Subject: VIRGIL C. SUMMER NUCLEAR STATION (VCSNS)
DOCKET NO. 50/395
OPERATING LICENSE NO. NPF-12
RESPONSE TO REQUEST FOR ADDITIONAL INFORMATION
REGARDING REQUEST TO USE ALTERNATIVES TO ASME BOILER
AND PRESSURE VESSEL CODE, SECTION XI, RELIEF REQUEST
RR-II-08 (0-C-02-3202)

**South Carolina Electric & Gas Company (SCE&G)
Virgil C. Summer Nuclear Station (VCSNS)
Response to NRC Request for Additional Information (RAI)
Regarding Inservice Inspection Relief Request
RR-II-08**

LIMITATION TO EXAMINATION

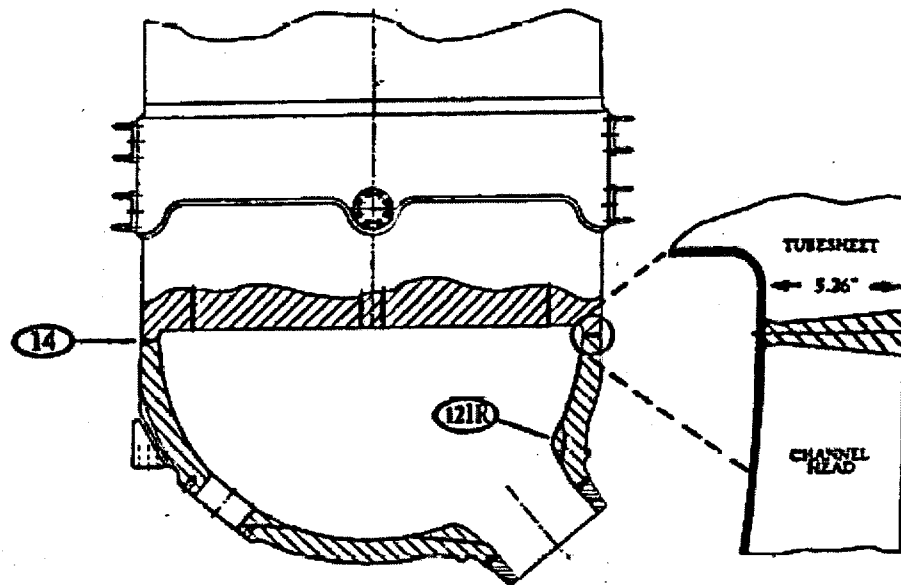
- b. The drawings (or pictorial discussion) showing the type and location of interferences with the Code-required ultrasonic examination. The drawing number was provided in the submittal but not the drawing itself. Identify the percent coverage that is able to be achieved on these nozzles using Code-required ultrasonic examinations.**

The drawing and the Preservice data are attached for reference.

The ultrasonic examinations performed for the detection of corner flaws per IWB-2500-7(d) consists of two circumferential scans, one clockwise and one counterclockwise. Both exams are performed with a specially designed 28 degree longitudinal wave alternative style transducer. This examination technique has scan interferences from manufacturing pads and the internally fabricated primary head drain hole. The combination of these interferences has limited the maximum achievable coverage to 80.4 per-cent of the examination volume.

a = 4" X 3.5" SET UP PAD
